DART AEROSPACE LTD	Work Order:	95323
Description: Crosstube Assembly (206L High Fwd)	Part Number:	D206-667-143
Inspection Dwg: D206-667-143 Rev: C		Page 1 of 2

D206-667-143
ASSEMBLY DETAIL
(VIEW LOOKING FWD)

DRAWING NO. D206-667-143	TITLE CROSSTUBE ASS'Y (206L HIGH FWD)	REV. C	DART AEROSPACE LTD ENGINEERING ORDER		D.E.O. NO. D206-667-143-C-1	SHEET NO. SHEET 1 OF 1	SCALE NTS
DRAWN 90	CHECKED ASS	MFG. APPR. [Signature]	APPROVED [Signature]	DE APPR. [Signature]			
DATE 11.07.15	DATE 11.07.20	DATE 11.07.21	DATE 11/07/21	DATE 11.07.21

DRAWING NO. D206-667-143	TITLE CROSSTUBE ASS'Y (206L HIGH FWD)	REV. C	DART AEROSPACE LTD ENGINEERING ORDER		D.E.O. NO. D206-667-143-C-2	SHEET NO. SHEET 1 OF 1	SCALE NTS
DRAWN AJS	CHECKED	MFG. APPR.	APPROVED		DE APPR.		
DATE 12.08.02	DATE 12.08.02	DATE 12.08.02	DATE 12.08.02		DATE 12.08.02	DATE 12.08.02

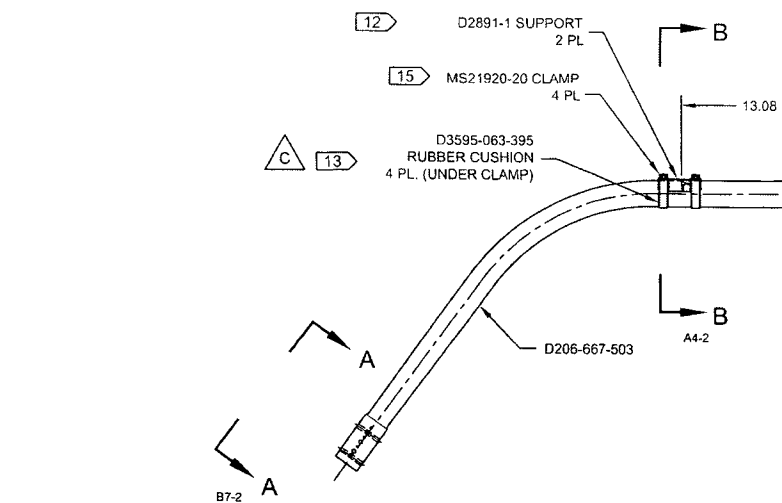
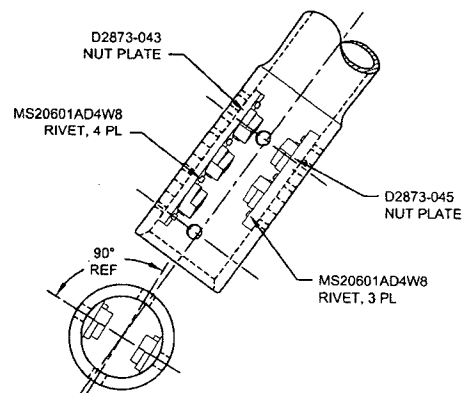
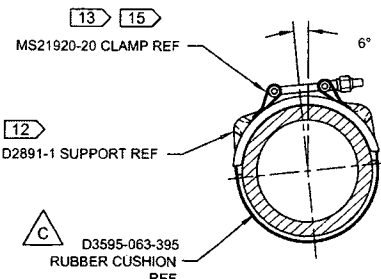
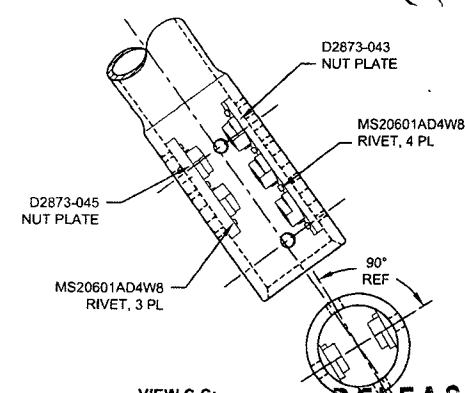
REPLACE MAGNOBOND WITH PROSEAL.

NOTE 12 & 15, SHEET 1 IS AMENDED AS FOLLOWS:

- 12) TO INSTALL D2891-1 SUPPORT: ABRABE MATING SURFACE OF SUPPORT AND CROSSTUBE WITH 180-GRIT SANDPAPER AND REMOVE RESIDUE WITH MEK (OR EQUIVALENT). APPLY A 0.04" TO 0.07" THICK LAYER OF PROSEAL 890 CLASS B-2 (OR AMS-S-8802 CLASS B-2) SEALANT TO MATING SURFACE OF SUPPORT.
- 15) TORQUE CLAMPS 80 TO 100 IN-LB. ENSURE AT LEAST 1.5 THREADS SHOWING IN SAFETY AND THAT NUT HAS NOT BOTTOMED-OUT AFTER TORQUING. **PRIOR TO PACKAGING, RE-CHECK TORQUE ON CLAMPS AFTER PROSEAL 890 SEALANT HAS CURED FOR 72 HOURS.**

C TURNING DETAIL

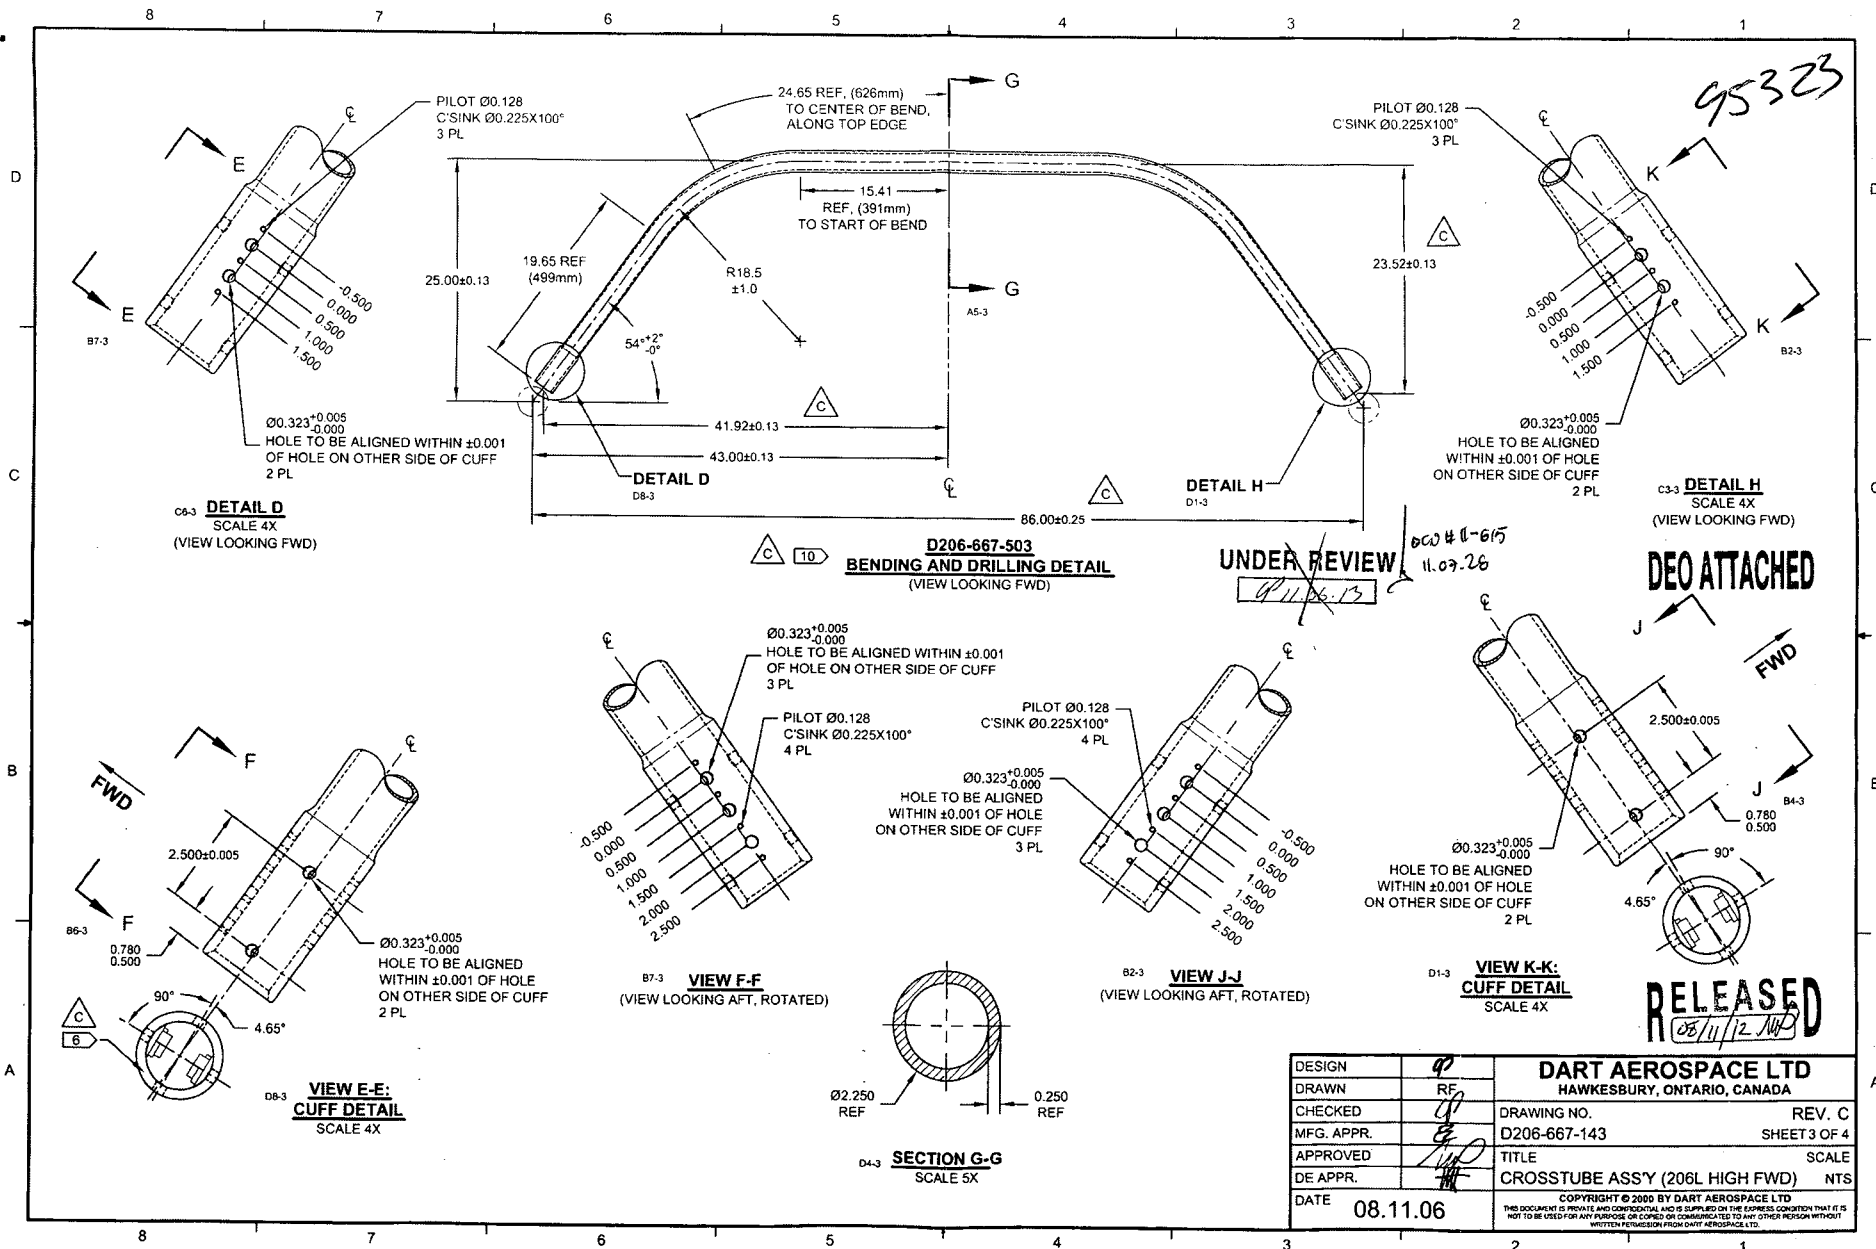
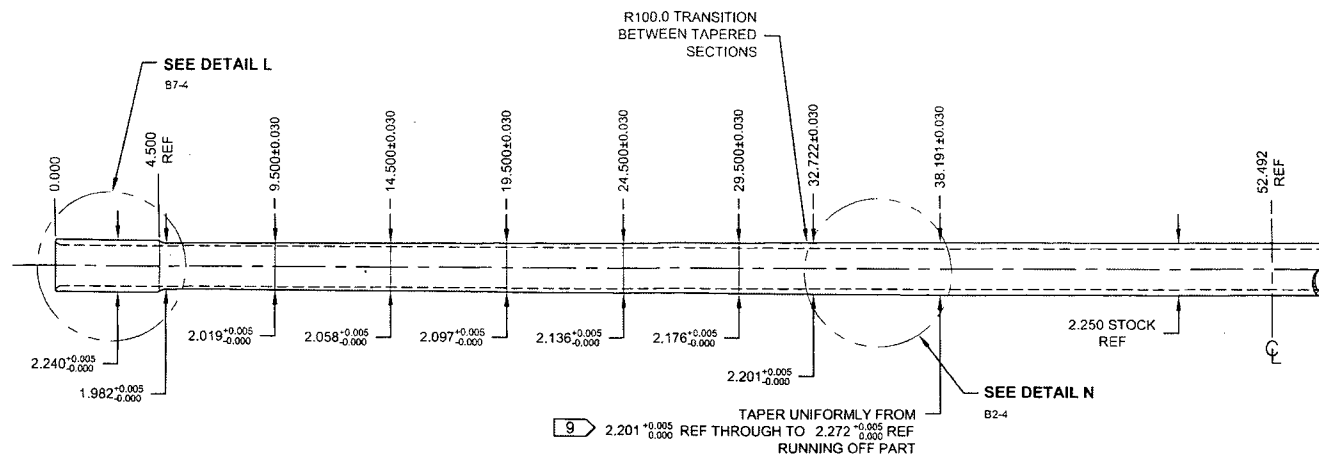
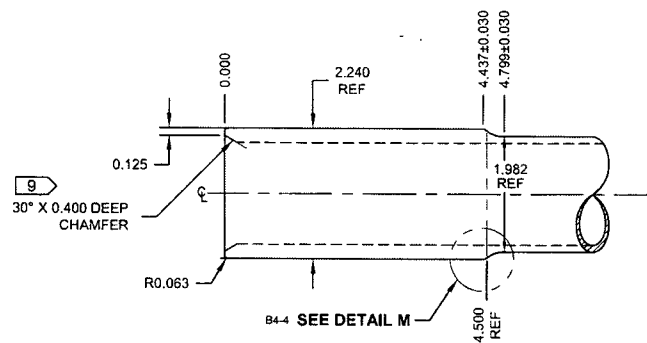
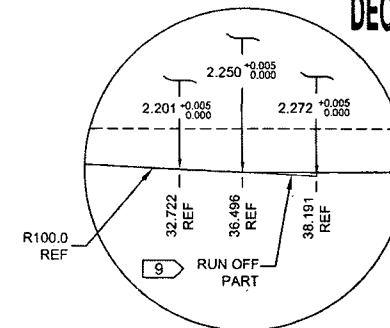
C	REVISE GENERAL NOTES/PART LIST (ZN D7-1); REORGANIZED VIEWS AND REFORMATTED DRAWING TO CURRENT STANDARDS. D3595-063-395 WAS D2856-400-594 (ZN D6-2 & A5-2); REMOVED REF. & ADD TOLERANCE (ZN D3-3, C4-3, C5-3); RELOCATED FLAG #6 (ZN A8-3) PER NCR 210; MOVED TURNING DETAIL & UPDATED TOLERANCE TO SHEET 4.	RF	08.11.06
B	ADD HOLES AND NUT PLATES FOR COMPATABILITY WITH BHT/AA SKUDTUBES	PH	05.07.26
A	NEW ISSUE	CP	00.11.17
REV.	DESCRIPTION	BY	DATE
DESIGN	RF	DART AEROSPACE LTD HAWKESBURY, ONTARIO, CANADA	
DRAWN	RF	DRAWING NO.	REV. C
CHECKED	RF	D206-667-143	SHEET 1 OF 4
MFG. APPR.	RF	TITLE	SCALE
APPROVED	RF	CROSSTUBE ASS'Y (206L HIGH FWD)	NTS
DE APPR.	RF	COPYRIGHT © 2006 BY DART AEROSPACE LTD THIS DOCUMENT IS PRIVATE AND CONFIDENTIAL AND IS SUPPLIED ON THE EXPRESS CONDITION THAT IT IS NOT TO BE USED FOR ANY PURPOSE OR COPIED OR REPRODUCED IN ANY MANNER WITHOUT WRITTEN PERMISSION FROM DART AEROSPACE LTD.	
DATE	08.11.06
